SERVICE BULLETIN

No. 899-CH

CARBURETOR

No. 905-CH

CROSS SECTION DIAPHRAGM AND HOUSING

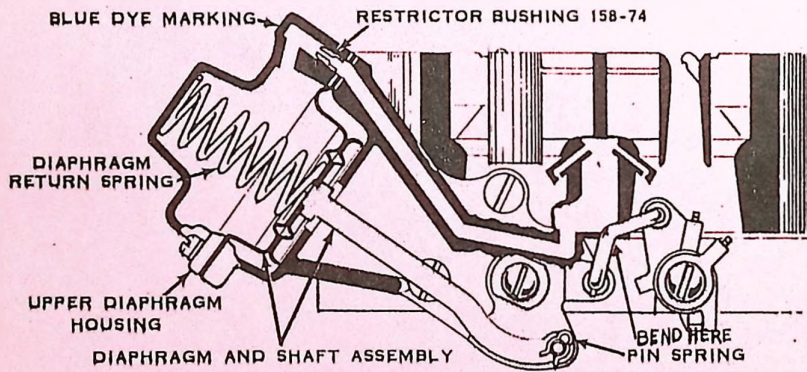
1. Restrictor bushing 158-74 has been released and installed in late production carburetors to slow the closing action of the vacuum operated secondary throttle valve.
 - a. Code date "A-5" or a blue dye on the diaphragm housing vacuum passage (see illustration) indicates the restrictor bushing has been installed in production.
 - b. The restrictor bushing 158-74 may be installed in early production carburetors by removing the upper diaphragm housing and diaphragm return spring. Press restrictor bushing into place (see illustration). Remove pin spring, disconnect diaphragm shaft at lower end, flex diaphragm to its lowest position, hold it there and reinstall diaphragm return spring, diaphragm housing. Tighten the cover screws alternately and evenly.
 - c. Attach diaphragm shaft at lower end and install pin spring. (See illustration)

FIGURE 1
 PUMP ADJUSTMENT

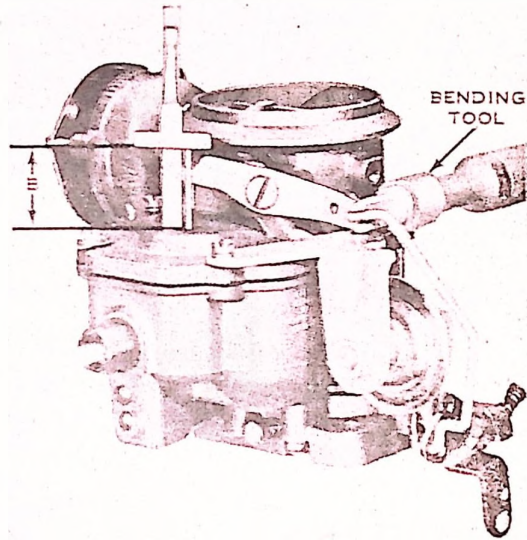
8. Adjust accelerator pump plunger stroke. Back out throttle adjustment screw and open choke valve so that throttle valves seat in bores of carburetor. Install throttle connector rod in outer hole (medium stroke) of throttle lever and inner hole of pump arm. The distance from the top of plunger shaft to bowl cover (not pump arm) should be $29/32''$. Adjust by bending pump connector rod (2180S) at lower angle; (2162S) at upper angle (use tool T109-213).
